Clarification requested by the EB:

Steam and Power Diagram considering all the three CDM projects in the complex

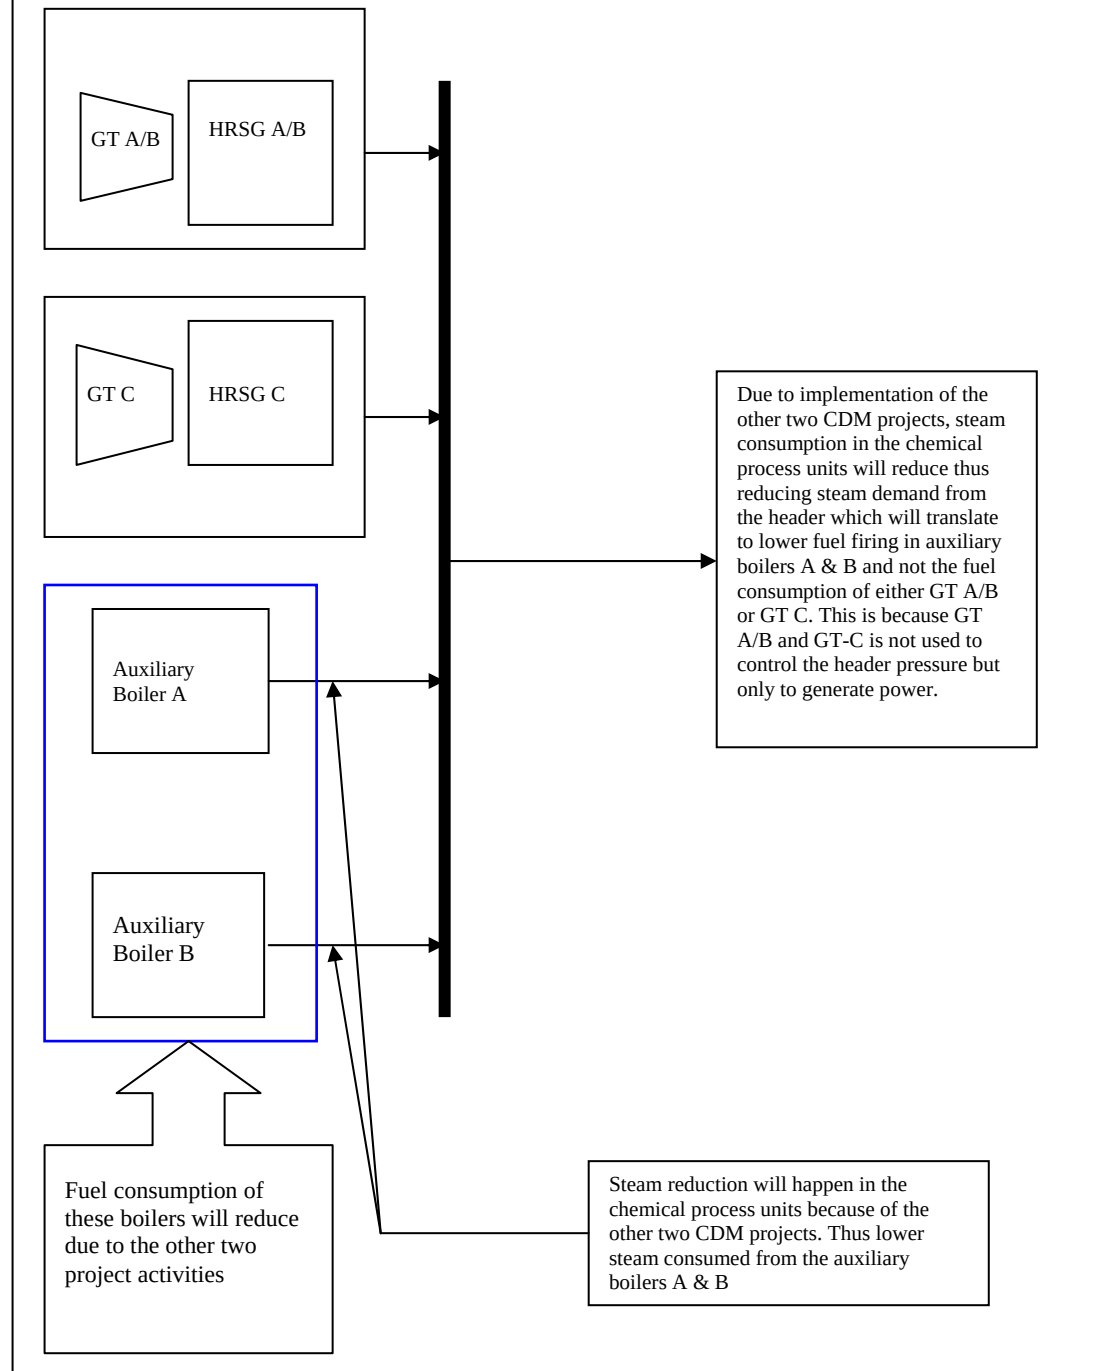
3. The PP/DOE is requested to clarify the overlapping of the project boundary with the other two proposed CDM projects by the same PP. The DOE is requested to further confirm how they have validated that there is no double counting of the energy savings between all the CDM projects in the unit.

The other two proposed CDM projects by the same PP involve reduction in steam demand in the chemical processing units (Ammonia plants) of the fertilizer unit and do not affect in any way the fuel combustion by the GT-C to generate power. The monitoring and emission reduction calculations are based on the difference between the station heat rate (fossil fuel consumption to generate unit power) of the GT-C. The baseline emissions are calculated as the reduction in the station heat rate (i.e. fuel to generate unit power) by the GT-C multiplied by the emission factor of the concerned fossil fuel (natural gas). Hence this formula gives the actual emission reductions due to lower fuel consumption by the GT-C to generate 1MW of

power. This is then multiplied by the power that would have been generated in the baseline to arrive at the total emission reductions. Thus the formulae proposed do not include fuel savings due to the two other CDM projects. Thus there is no overlapping of the project boundaries of the other projects with the one under consideration. Please refer to the figure below representing the emission reductions by all the proposed CDM projects of the PP.

Steam demand of the process units will decrease due to implementation of the other two proposed CDM projects which will lead to lower steam demand from the common steam header. This will lead to lower fuel firing in the auxiliary boilers A and B. Fuel firing in the GT-C (the monitored quantity) will not be affected because it does not determine the steam header pressure. The only boilers primarily responsible for controlling the header pressure are the auxiliary boilers A & B.

Hence there is no possibility of accounting emission reductions due to the other two CDM project activities in the proposed monitoring plan of the project activity under consideration as outlined in the PDD submitted to request for registration.
